# PRODUCT BULLETIN

**Bulletin No:** PB430  
**Issue Date:** 2-19-2019  
**Effective Date:** 2-19-2019

**Description/Title:**  
Specification Change on DPF-200 Depaneling System

**Part No:**  
DPF-200-E

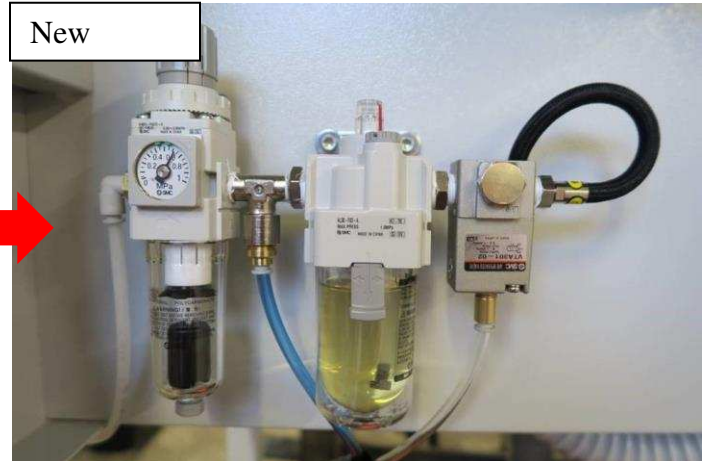
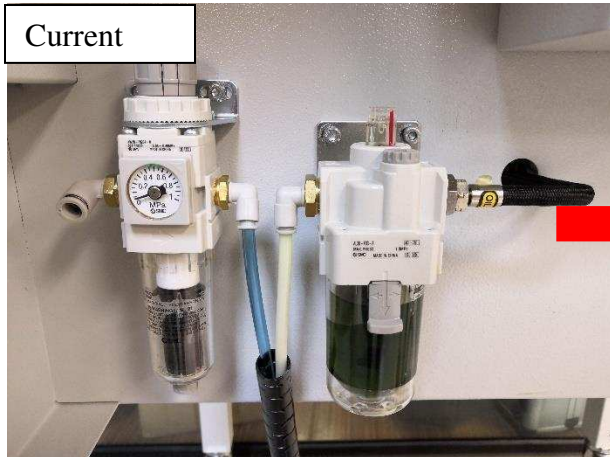
Starting from serial number 00000604, the DPF-200 depaneling system will come equipped with an improved air regulating and lubricating system. The new system is designed to further control the lubrication oil feed rate even under heavy usage. This change will not affect the performance and other specification of DPF-200.
